Subject: 49 CFR Part 579.5 Monthly Communications – February 2016

**INDEX OF SERVICE BULLETINS,
NOTICES, AND COMMUNICATIONS TO DEALERS**

Figure 1 - Article 16-0014

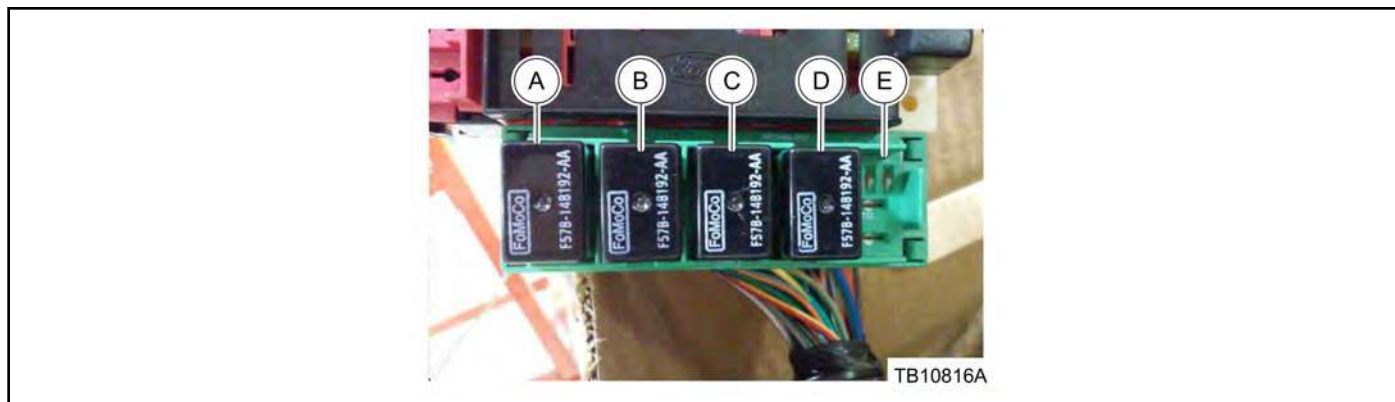
1. Is the hazard lighting, turn signal operation or TT lighting not functioning properly?
 - a. Yes - proceed to step 2.
 - b. No - this article does not apply. Refer to Workshop Manual (WSM), Section 417-01 for normal diagnostics.
2. Locate the central junction box (CJB) in the lower left side of dash. Remove and discard the following relays: (Figure 1)

- A - Trailer Tow Right Turn
 - B - Trailer Tow Left Turn
 - C - Right Turn
 - D - Left Turn
 - E - Empty
3. Install new 4-terminal relays in the CJB in positions A, B, C and D. (Figure 1)

Figure 1 - Article 16-0018

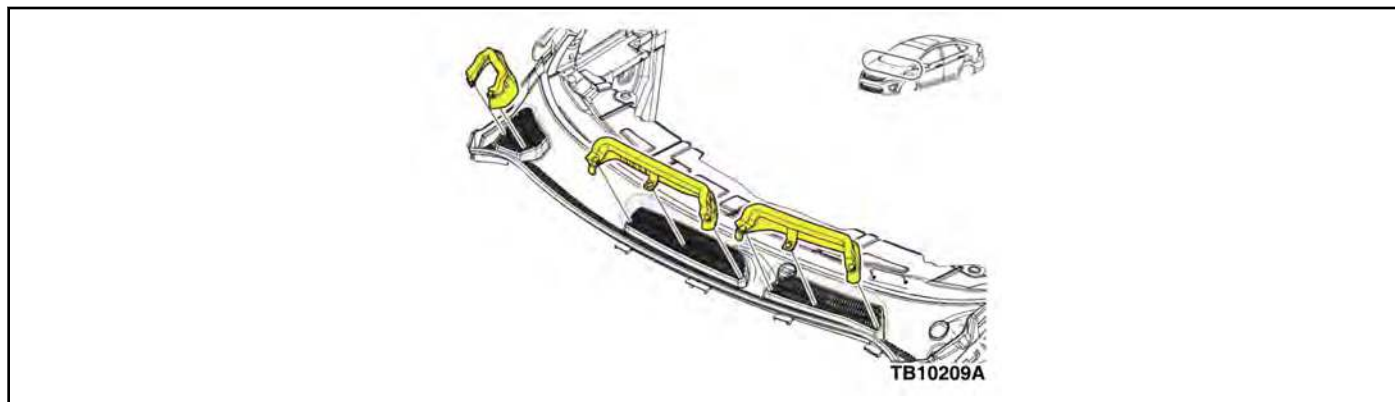
1. Does the vehicle have an engine block heater and heated seats?
 - a. No - proceed to Step 2.
 - b. Yes - refer to Refer to Workshop Manual (WSM), Section 412-00 for normal diagnostics.
2. Replace the cabin air filter. Refer to Workshop Manual (WSM), Section 412-00.
3. Open the hood and inspect for the presence of foam deflectors on the air inlet openings of the cowl opening grille. Are deflectors present? (Figure 1).

- a. No - proceed to Step 4.
 - b. Yes - remove and discard the foam deflectors. Proceed to Step 4.
4. Remove the cowl panel grille. Refer to WSM, Section 501-02.
5. Remove all previous level screen assemblies from the bulkhead.
6. Install the new screen assembly. (Figure 2)

Figure 2 - Article 16-0019

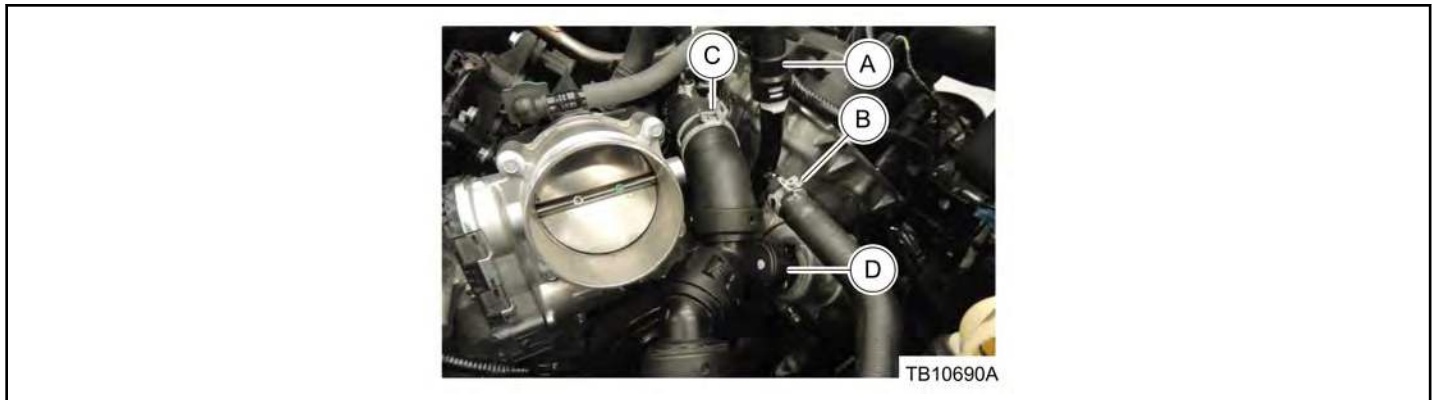
- a. No - this procedure does not apply. Refer to WSM, Section 303-03 for normal diagnosis.
 - b. Yes - proceed to Step 3.
3. Drain the cooling system. Refer to WSM, Section 303-03.
4. Remove the air cleaner outlet pipe. Refer to WSM Section 303-12.
5. Remove the bolts and position the degas bottle aside.
6. Completely cover the accessory drive belts with waterproof plastic.
7. Disconnect the heater outlet hose from the heater outlet tube. (Figure 2A)

8. Release the clamp and disconnect the lower degas bottle hose from the heater outlet tube. (Figure 2B)
9. Release the upper radiator hose clamp from the heater outlet water connection. (Figure 2C)
10. Pull the upper radiator hose T-connector spring clip up until the end of the clip is in the detent on the quick connect coupling and remove the upper radiator hose T-connector from the thermostat housing. (Figure 2D)
11. Remove the bolt and the heater outlet tube.
12. Install the new heater outlet tube and the bolt. Tighten to 10 Nm (89 lb-in.).
 - a. Lubricate the O-ring seal on the heater outlet tube with clean engine coolant.
13. To install the remaining components, reverse the removal procedure.

Figure 3 - Article 16-0020

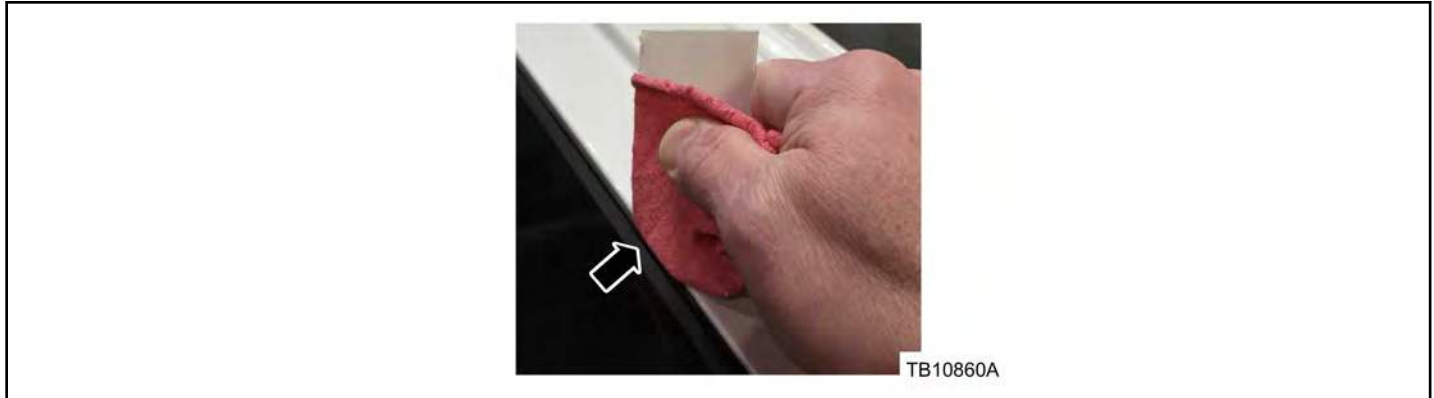
7. Apply isopropyl alcohol onto a clean folded shop rag and insert it between the rear fixed glass panel seal and the roof opening sheet metal. (Figure 3)

- a. Folding the shop rag over a flexible piece of plastic such as an old credit card or a thin piece of plexiglass will assist in the cleaning process.
 - b. Slide the isopropyl alcohol-soaked shop rag around all sides of the fixed panel glass.
8. Apply a light film of Krytox® grease to the entire sheet metal roof opening of the movable glass panel and the front edge of the movable glass seal.
9. Hold the wind deflector down and apply Krytox® grease to both openings of the left and right front set plates. (Figure 4)

Figure 5 - Article 16-0021

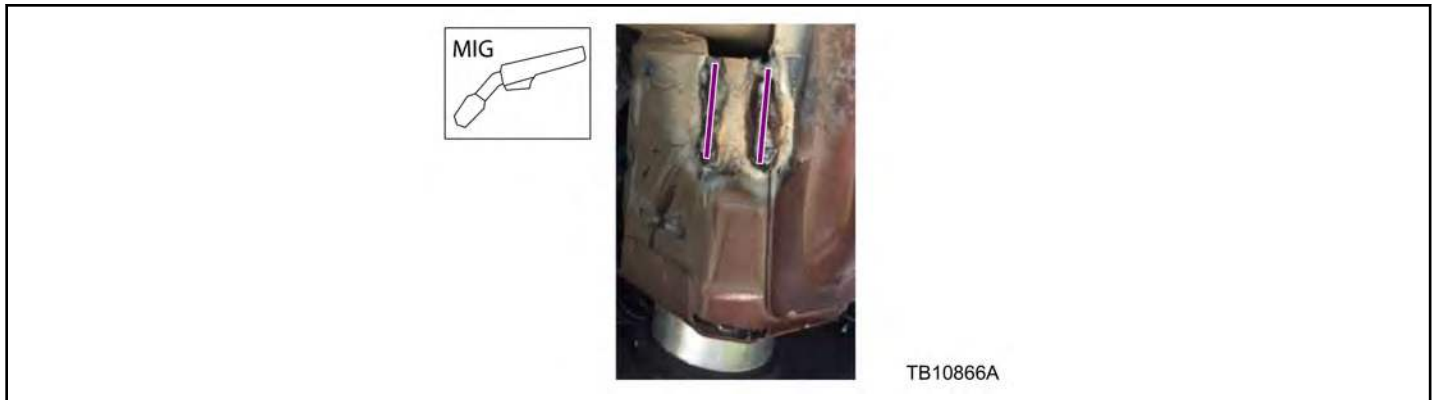
11. Using a MIG welder, weld the previously cut sheet metal to repair the bracket. (Figure 5)

Figure 1 - Article 16-0022

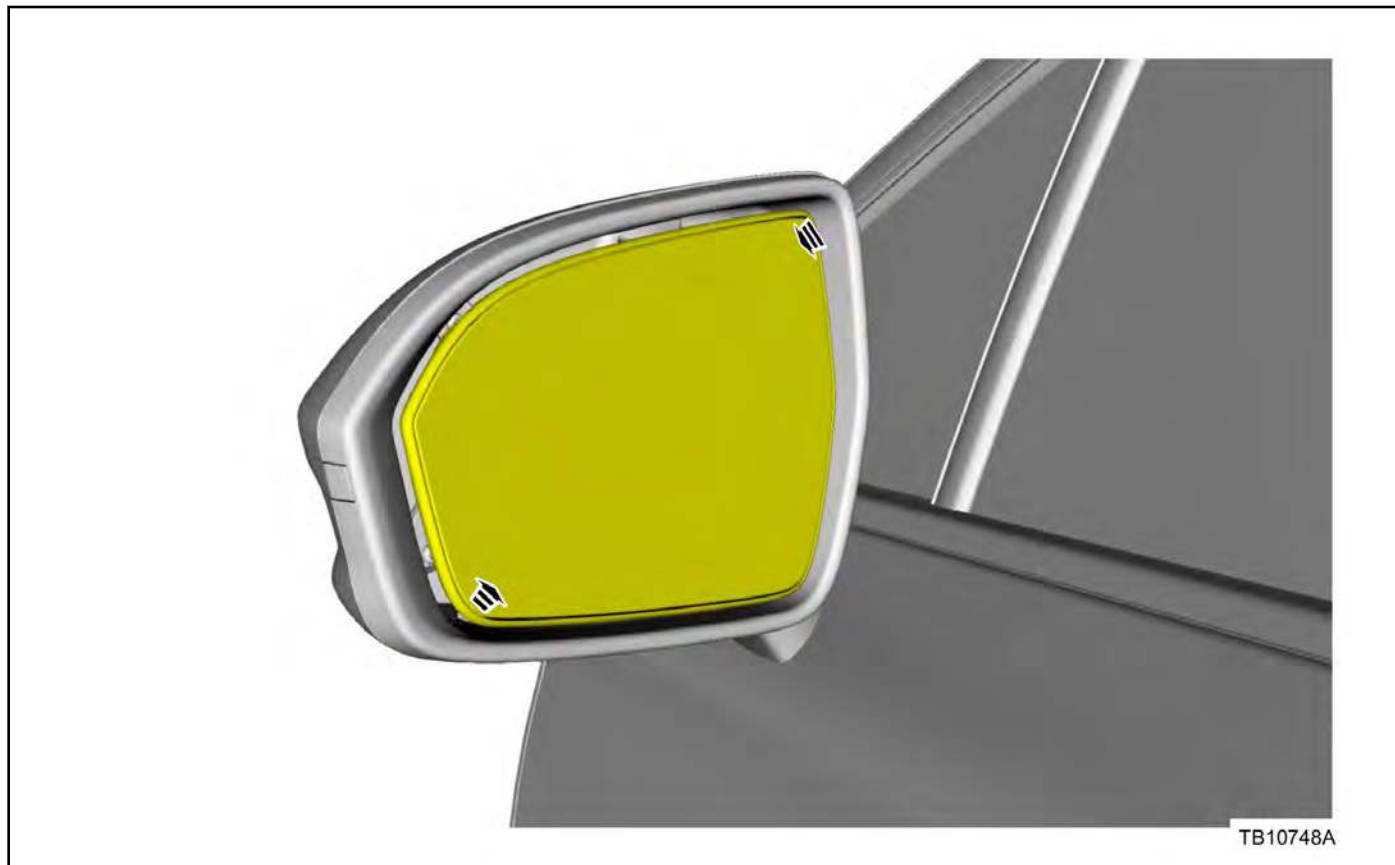
1. Position the exterior mirror glass for access. (Figure 1)

Figure 2 - Article 16-0022

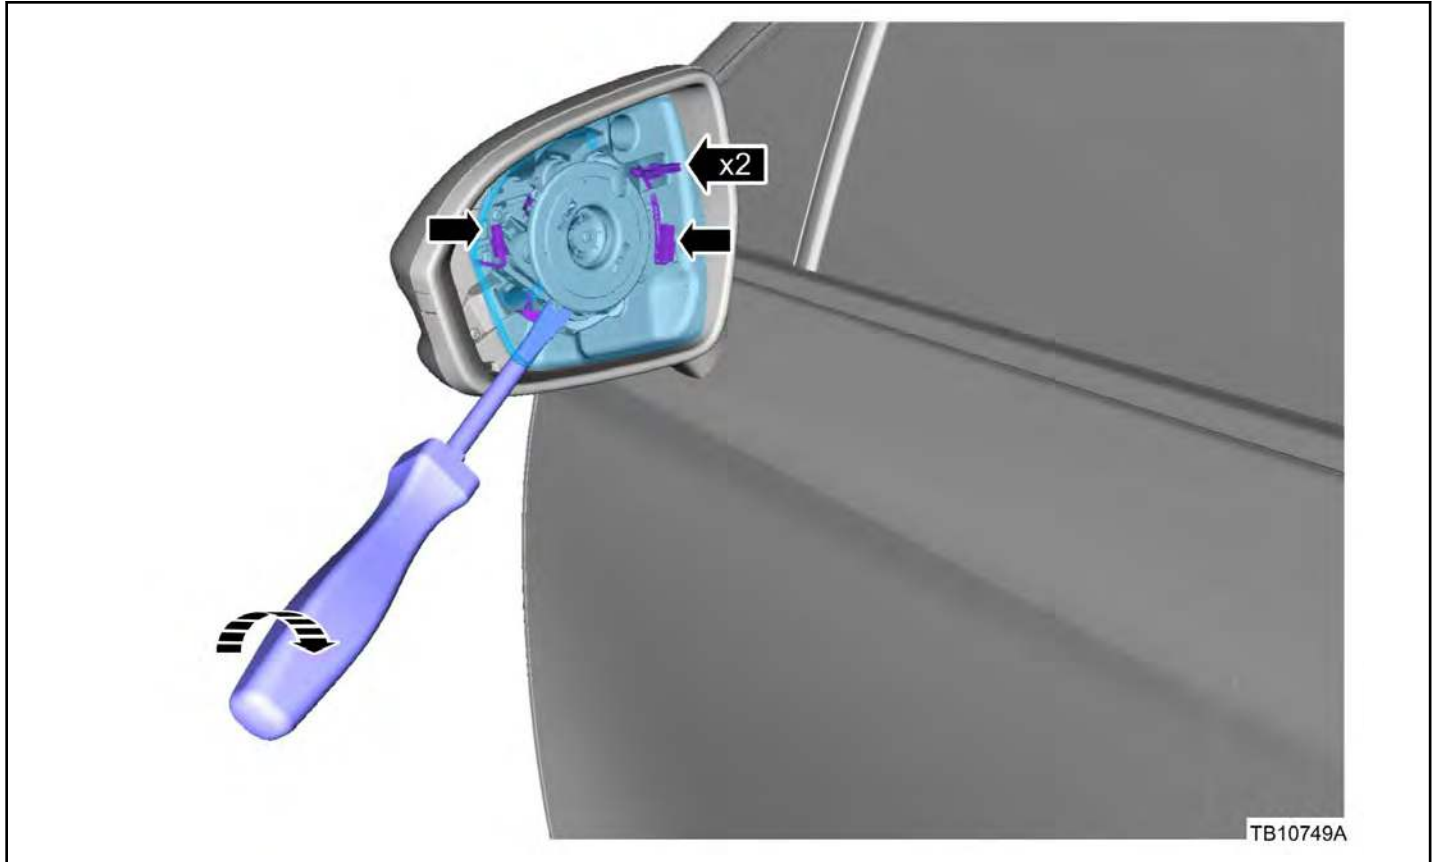
2. Release the mirror glass and disconnect the electrical connectors. Use of a non-marring plastic trim tool is recommended to release the mirror glass. (Figure 2)

Figure 4 - Article 16-0022

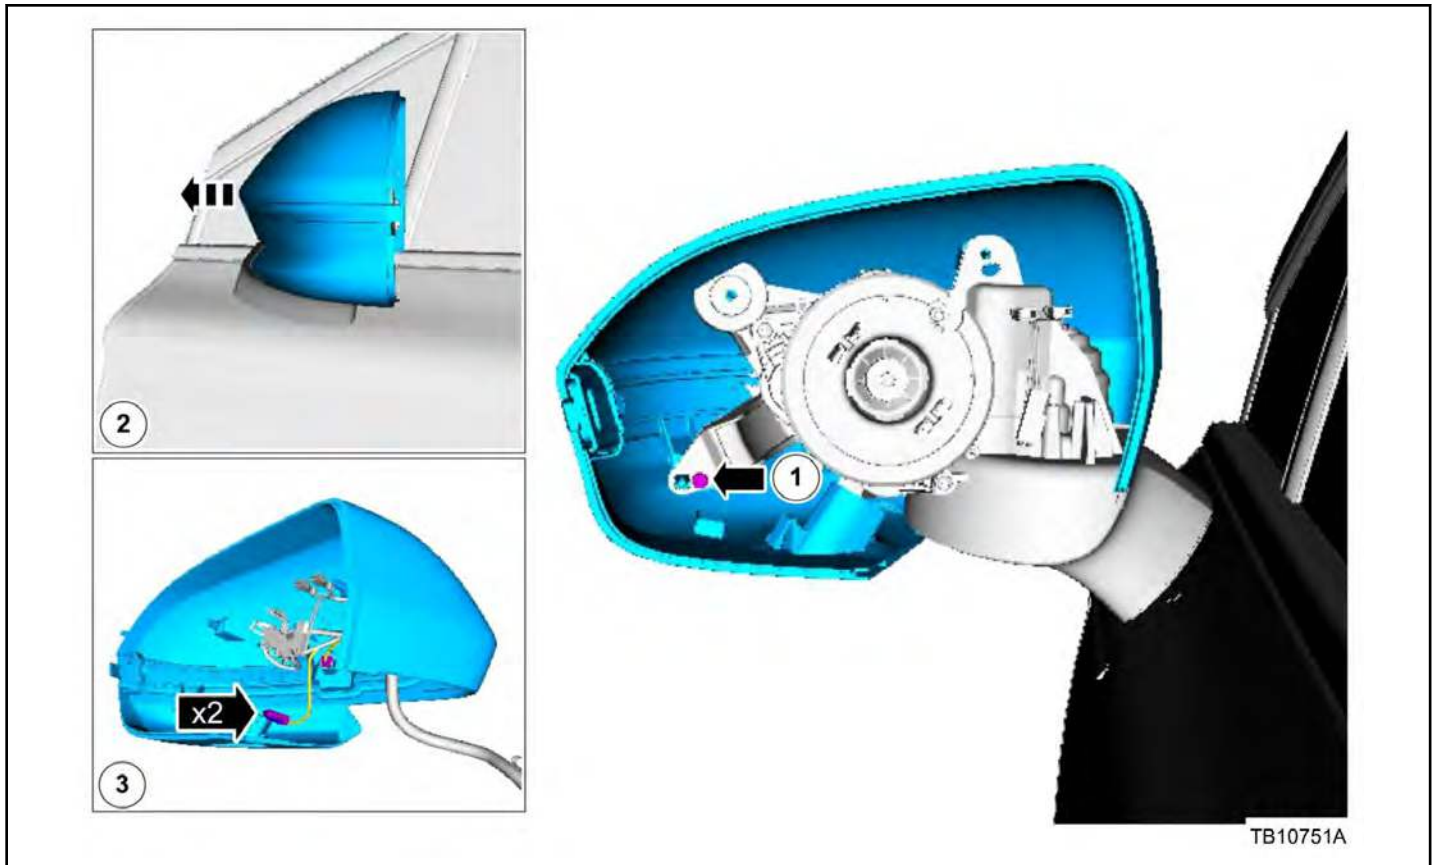
4. Remove the screw and position the mirror cover aside. (Figure 4)

Figure 6 - Article 16-0022

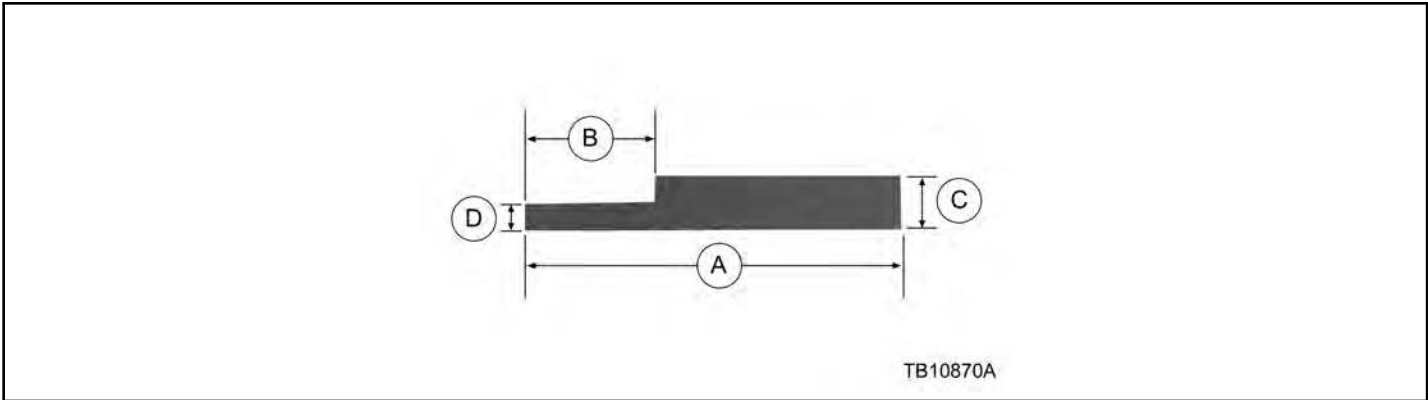
7. Dry the surface using a lint free cloth.
8. Cut one piece of PVC soft foam tape 164-R4901 from Rotunda Squeak and Rattle kit 164-R4900 as shown. (Figure 6)

- A - 155 mm (6 inches)
- B - 51 mm (2 inches)
- C - 22 mm (7/8 inch)
- D - 9 mm (3/8 inch)

FIGURE 2a

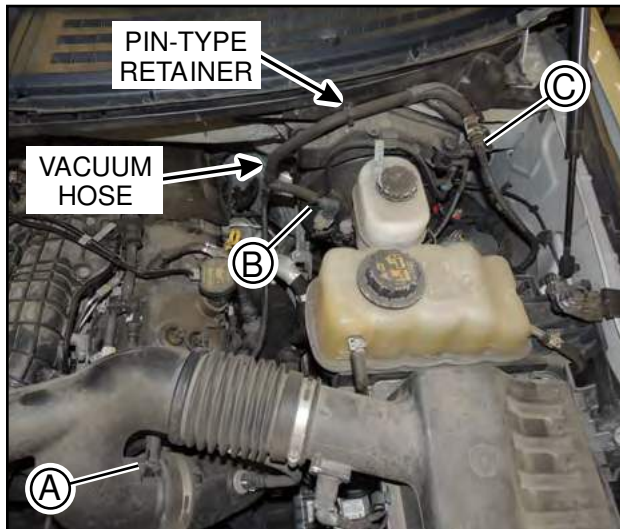
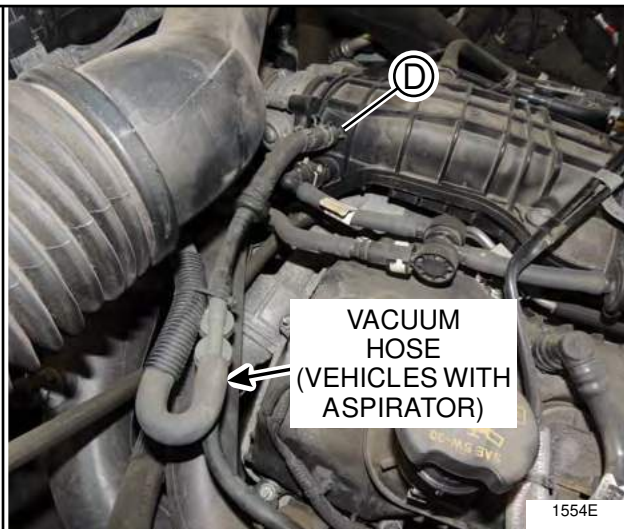
1. Disconnect the vacuum hose from the following locations (see Figures 2a and 2b):
 - a. Air cleaner outlet pipe - for vehicles equipped with an aspirator.
 - b. Brake booster.
 - c. Brake vacuum supply hose.
 - d. Intake manifold.
2. Disconnect the vacuum hose pin-type retainer, remove and discard the vacuum hose. See Figure 2a.

FIGURE 3a

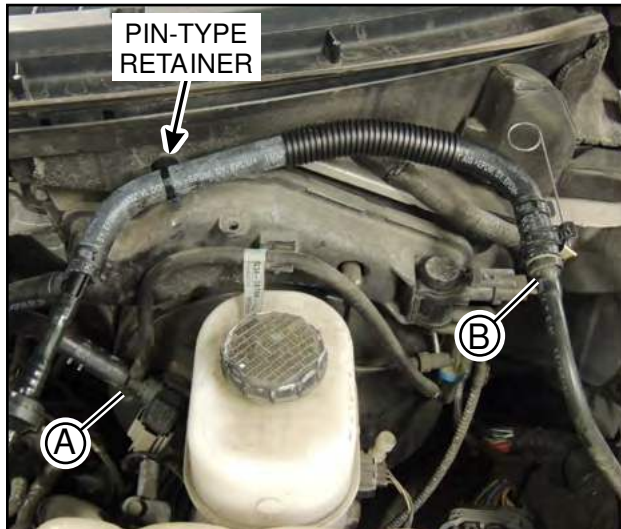
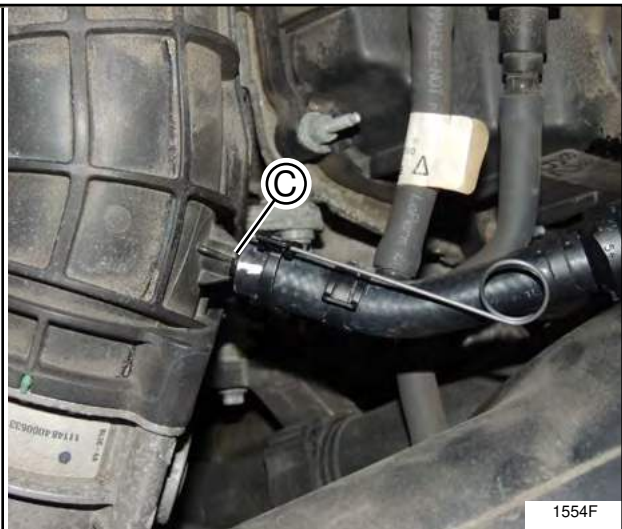
NOTE: During installation of the *new* vacuum hose, verify the alignment mark on the vacuum hose is aligned with the barb on the intake manifold. See Figure 3b.

3. Install the *new* vacuum hose and connect the pin-type retainer. See Figure 3a.
4. Connect the vacuum hose at the following locations (see Figure 3a and 3b):
 - a. Brake booster.
 - b. Brake vacuum supply hose.
 - c. Intake manifold.

FIGURE 2

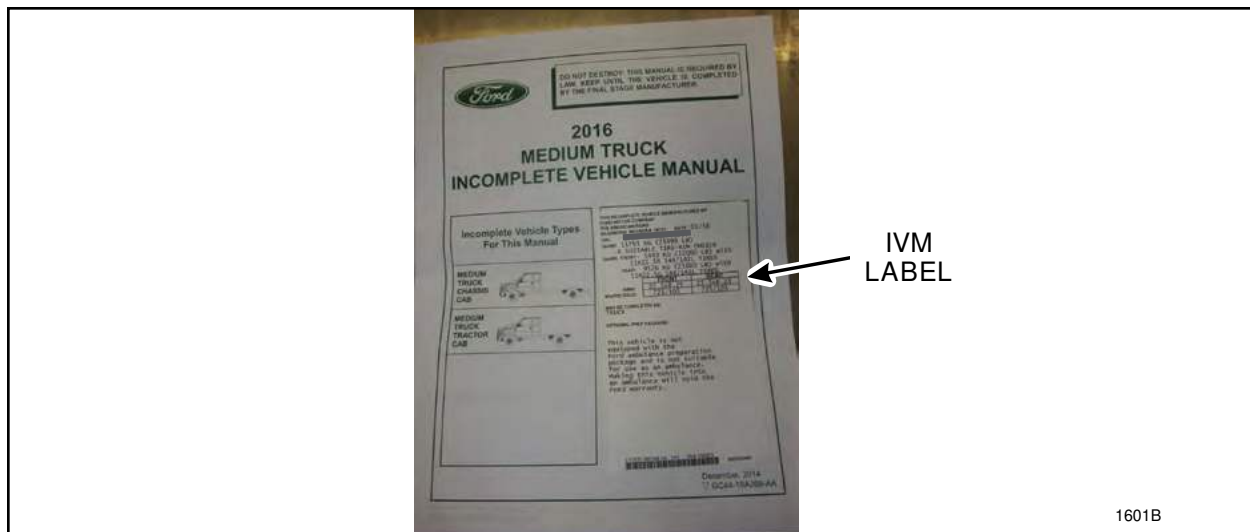
2. Locate the IVM and replace the IVM Label with an updated label. See Figure 2.

- a. Locate and remove the original IVM Label from the IVM.
- b. Adhere all the pieces of the original label to the paper provided with the *new* labels, and return to Ford Motor Company in the envelope provided.
- c. Install the *new* label in the same location as the original.
